Interactive comment on “Hydrogeomorphological analysis and modelling for a comprehensive understanding of flash-flood damaging processes: The 9th October 2018 event in North-eastern Mallorca” by Joan Estrany et al.

The response of the questions and comments provided by the anonymous RC1 referee will be addressed in a point by point format, being the comments from RC1 in bold.

RC1 - Anonymous Referee #1 Received and published: 18 December 2019

Fig. 1. Figure 1. Workflow of the experimental design.

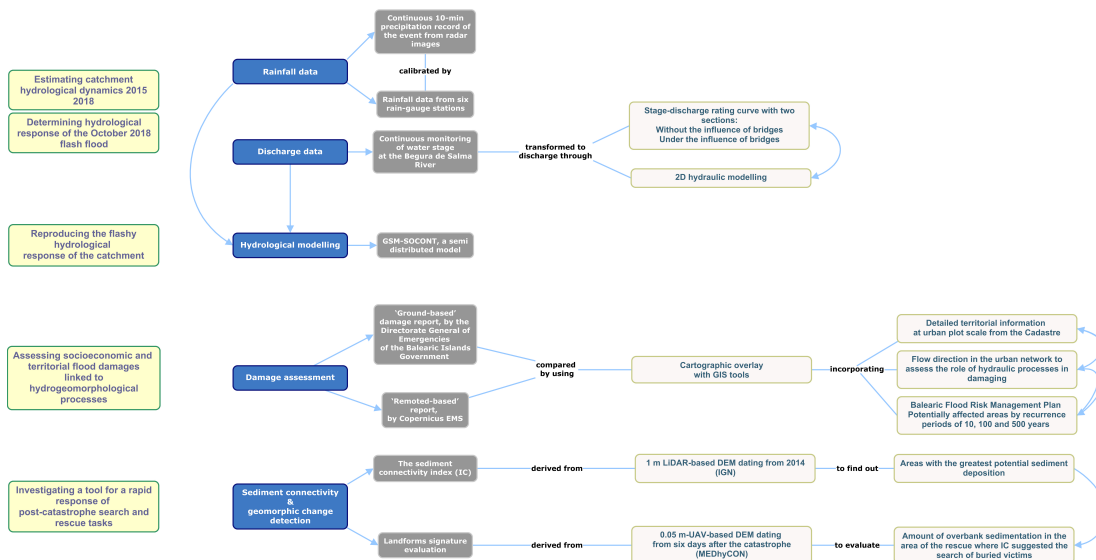
L109: since the structure of the paper is complex, a brief introduction to the next Sec-

tions could be useful

We believe that the specific objectives deployed in the last part of section 1. Introduction are providing the conceptual structure of the paper that is performed by the typical structure of sections in a scientific paper such as Materials and methods, Results and Discussion. In addition, the first paragraph of the section 2. Materials and Methods is really useful to provide a comprehension of the paper structure. It is true that the explanation provided in this first paragraph is in terms of methods, but they are completely related with the structure of the paper. However, to provide more consistence to the structure, we have completed this first paragraph of the section 2. Materials and methods, as follows (Lines 122-124 of the new MS version): “Finally, high-resolution digital elevation models (HR-DEM) were generated by LiDAR 2014 data from the Spanish National Geographic Institute and by imagery captured through a low-cost UAV just six days after the catastrophe to calculate a sediment connectivity index (IC) and measure geomorphic changes (Fig. 1)”. In addition, we have designed and performed a new figure with a workflow of the different steps and their relation to the objectives of the manuscript. This is the new Figure 1, captioned as “Methodological workflow of the research study”.

Fig. 2. Figure S2. Scatterplot of recorded rainfall in meteorological stations and estimated rainfall by using different grid radar.

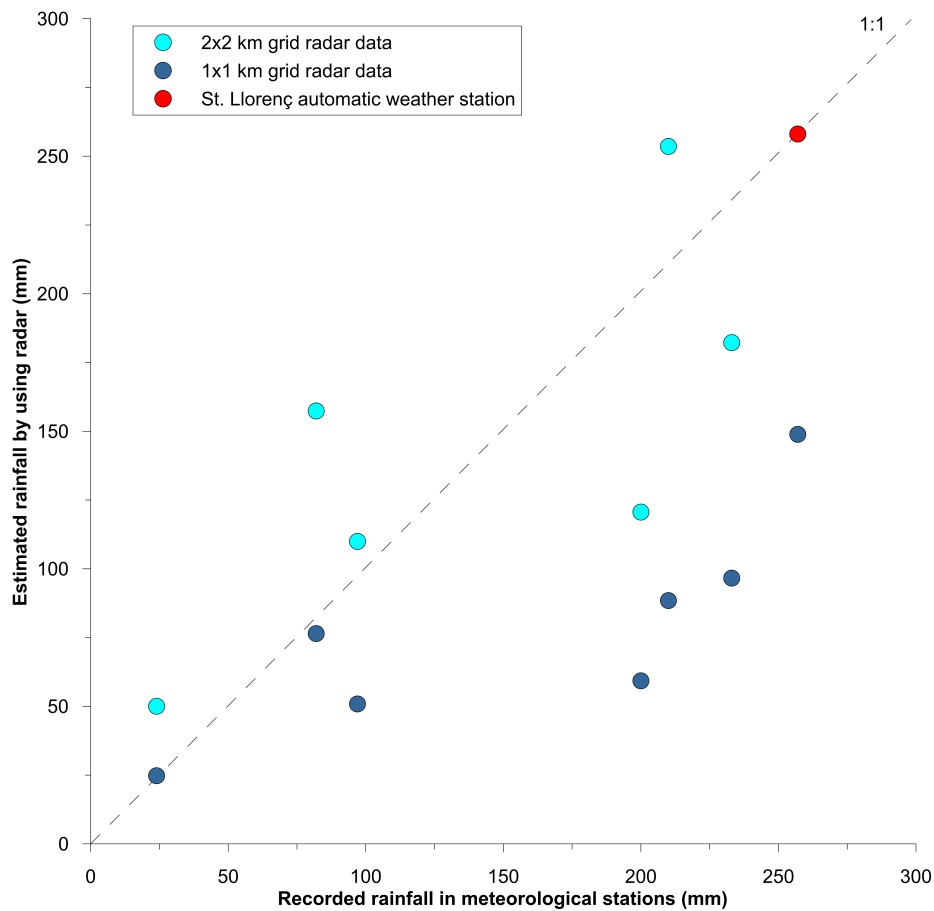
LL206-213: this paragraph is not clear. What were the driving data for this analysis? Those provided by the rain gauges surrounding the catchments? If so, the authors should provide some proofs about the reliability of their analysis (e.g., a scatterplot, even in the Supplement). Furthermore, if rainfall data are gridded in 2x2 square cells, why in fig. 6 it looks like they are spatially interpolated? Maybe, because they are related to the GSM-SOCONT scheme (for which the authors refer to inverse distance weighting)?

We have rewrote the paragraph in order to clarify this issue. We have also generated a scatterplot in which the two estimations are compared against the observed rainfall (the new Figure S1).

The new paragraph in Lines 262-270 of the revised MS: “With the set of coefficients $a=300$ and $b=1.4$, the maximum amount of estimated rainfall using radar data clearly underestimated the observed rainfall, with a PBIAS of -50.6% and an estimation of ca. 149 mm as the maximum rainfall amount, compared with the 257 mm recorded at the Sant Llorenç des Cardassar rain gauging station (see Fig. 2c). Instead of using the recorded rainfall in gauging stations to calibrate the radar-based rainfall, a correction method of the rainfall estimation based on spatial resampling was posited here. Accordingly, the 2*2 km spatial resolution of radar data was resampled by assigning to each grid cell the value of the maximum amount of estimated rainfall at 1*1 km. By this method, the regression coefficient reached $R^2= 0.8$, a PBIAS of only $+2.6\%$ and 258 mm as the maximum estimated rainfall amount, which fitted the rainfall observed at that point (Fig. S1)”. The estimated rainfall from gridded radar data was directly used in the SOCONT scheme without inverse distance weighting. Only the temperature is interpolated. This has been clarified as follows (see lines 365-367 of the revised MS): “Resampled 1 km resolution radar data (see subsection 2.3) were used in the model to obtain precipitation for each elevation band by including all 1 km resolution points falling within each elevation band”.

Fig. 3. Figure 8 (a) Map of the damage level classification of buildings and water stage reached in the different affected zones at Sant Llorenç des Cardassar according to the Balearic Islands Autonomous Government

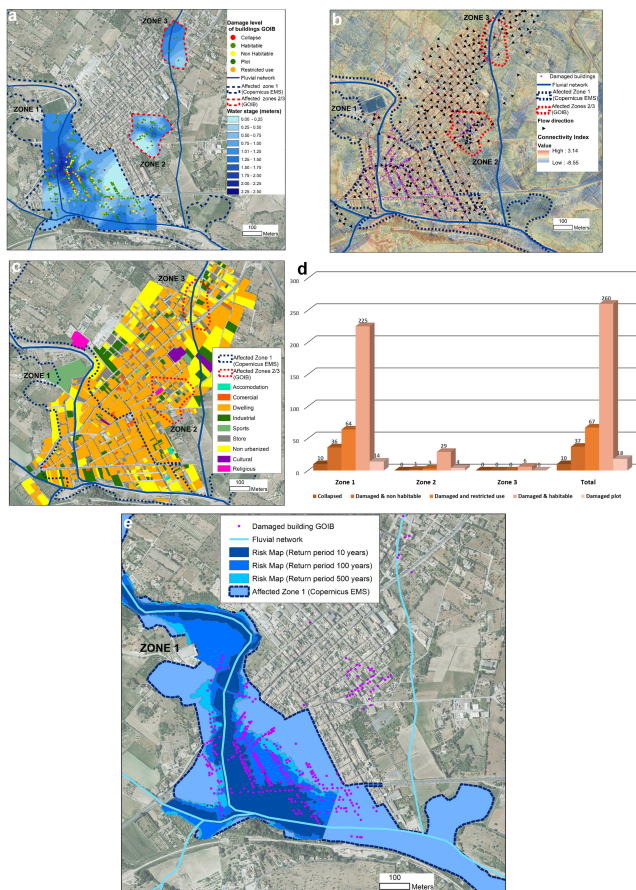
Figure 7 is not very clear. Maybe it could be divided into more figures. However: in Fig. 7a, are the red dashed polygons all derived from the Copernicus EMS? Also zone 2 and 3? Do the latter perfectly correspond to the Government survey? Figs. 7b and 7c are not very readable/useful, in my opinion.

The Figure 7 is the Figure 8 in the revised MS. Once clarified this structure detail, we must recognize that the legend in Fig. 7a was not comprehensible due to “Affected zones” did not help to observe what are the source for determining the affected zones; i.e., Copernicus EMS or Government survey. As a result, we have modified the sub-figures “a”, “b”, and “c”. With this modification, we believe that sub-figures “b” and “c” are totally useful due to are areas not detected by Copernicus EMS and we explain throughout the main text their damage level supported by these sub-figures.
